CALIFORNIA COASTAL COMMISSION

REGULAR CALENDAR
STAFF REPORT AND PRELIMINARY RECOMMENDATION

Application No.: 6-99-48

Applicant: Beach King, Inc.

EXHIBIT NO. 3
APPLICATION NO.
6-99-48
Public Views
California Coastal Commission

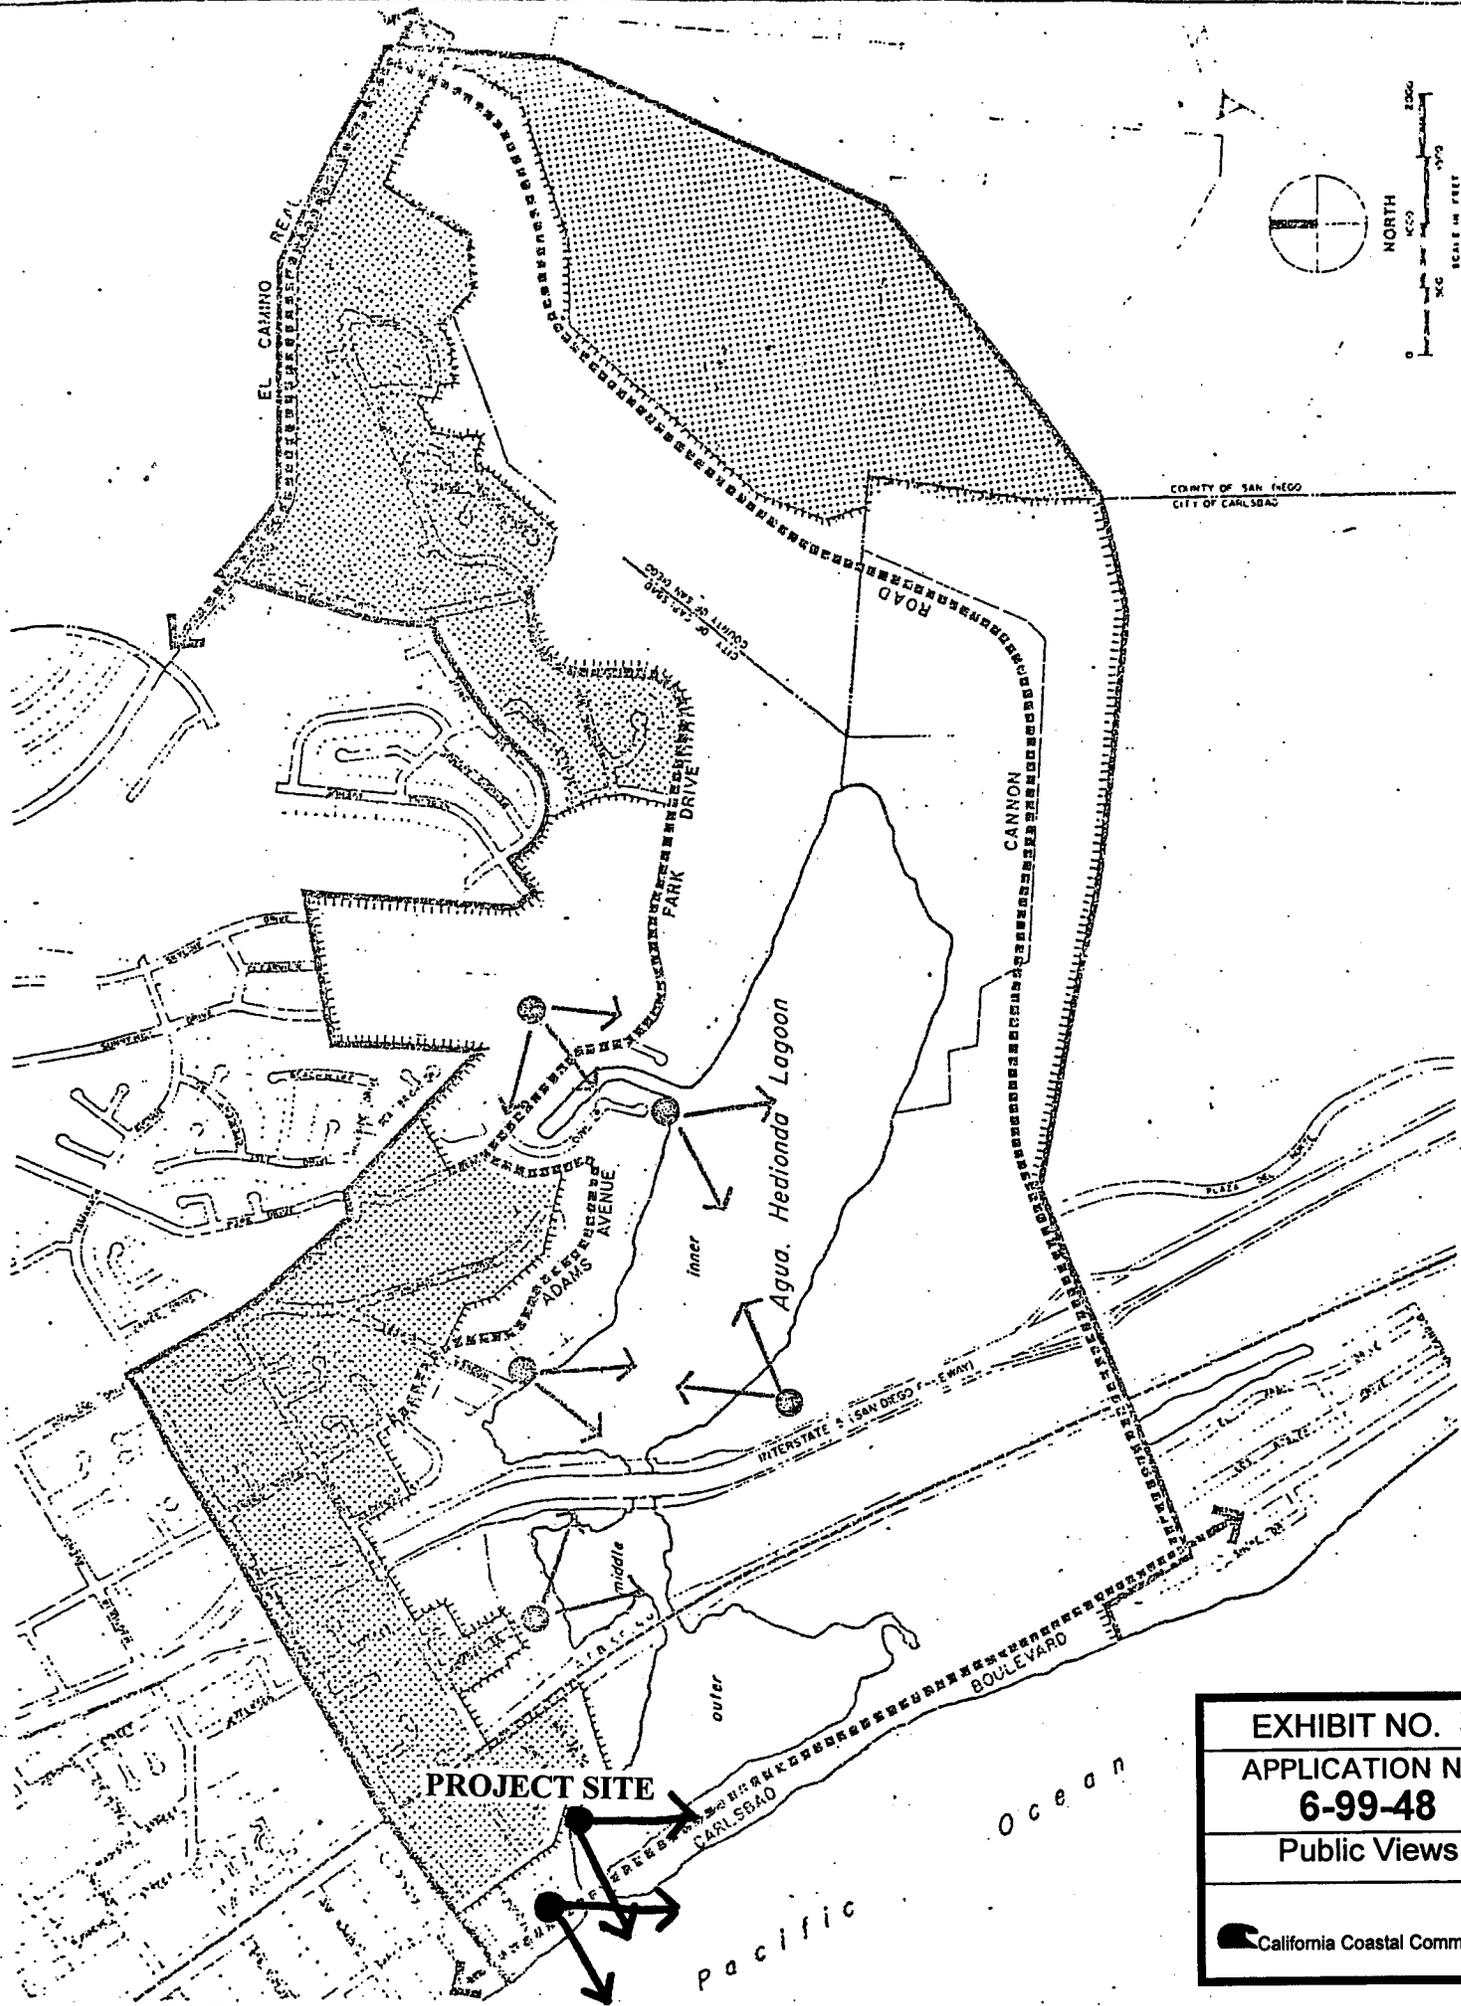
The project site is on a visually prominent inland bluff overlooking Carlsbad Boulevard (a designated scenic corridor and first coastal road), Carlsbad State Beach and the Pacific Ocean. It is also within 300 feet of the outer basin of Agua Hedionda Lagoon. The certified Agua Hedionda Lagoon Land Use Plan designates various areas as vista points. The site of the proposed project is within a designated vista point. Currently views to the lagoon and ocean are available across the site from the end of Chinguapin Avenue, which is a public street situated to the east/northeast of this site. LUP policy 8.2 provides that "Special vista points and viewing areas shall be preserved, and made available to the public, as indicated on Exhibit K "(ref. Exhibit #3).

As noted, Section 30251 of the Coastal Act requires that public views to and along the coast be protected in conjunction with new development. As such, within the proposed development, views from Chiquapin Avenue to the south and west need to be preserved. In addition, views of the site from the lagoon, beach and adjacent road need to be addressed. This identified public viewing area is one of only a few places in Carlsbad where public views are identified in LCP. The proposed 50-foot wide view corridor left from developing the project site with 3 houses and future single family residences on two lots to the north of the project site will not meet the intent of the LCP nor satisfy the requirements of Section 30251 of the Coastal Act. What is left provides only a "tunnel" view corridor directly to the west, not the panoramic view corridor envisioned by the LUP. Views to the south (Agua Hedionda Lagoon) will also be a "tunnel" view that will be dominated not by the lagoon but the Encina Power plant and its tall smokestack, horizon views of the ocean will be lost or partially obscured, Carlsbad State beach and Carlsbad Blvd. views will be lost or partially obscured. The Commission notes that views from the ROW along the bluff edge are panoramic; however, people should have those views from the street end. In other words visitors should not have to walk across an unimproved street end to gain those views. The presence of the proposed structures adds an intimidating factor which would discourage the public from walking out to the bluff edge. Section 30251 of the Coastal Act requires that more, not less emphasis be placed on reducing visual impacts to and along the coast.
